Replacement of 8DB 355 025-441 by 8DB 355 013-761

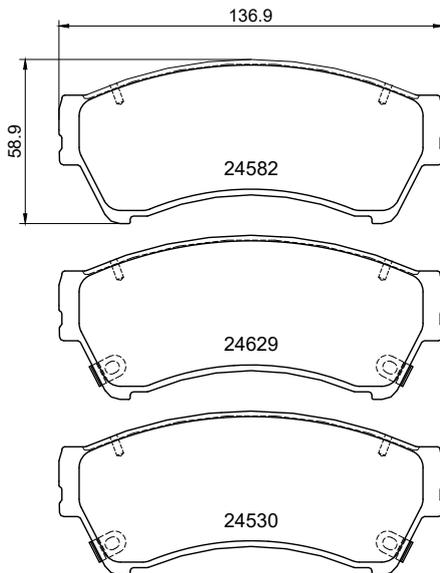
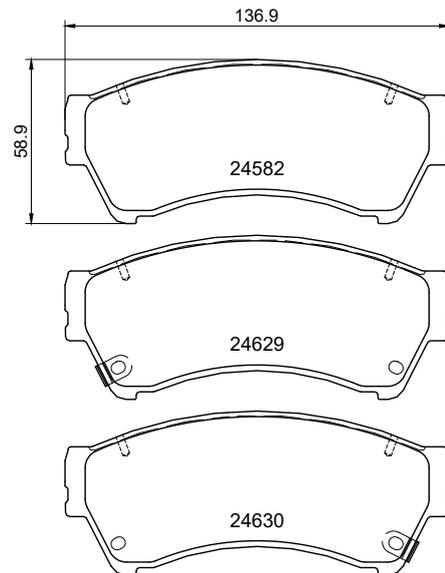
Hella Pagid is now able to harmonize the references 8DB 355 025-441 and 8DB 355 013-761. It was proven that 8DB 355 013-761 can also cover the applications of 8DB 355 025-441. Therefore Hella Pagid will replace 8DB 355 025-441 by 8DB 355 013-761.

Hella Pagid decided to reduce the thickness of 8DB 355 013-761 to 17,2, which makes the two references equal and therefore Hella Pagid decided to harmonise 8DB 355 025-441 with 8DB 355 013-761. There will be no difficulties during installation and operation.
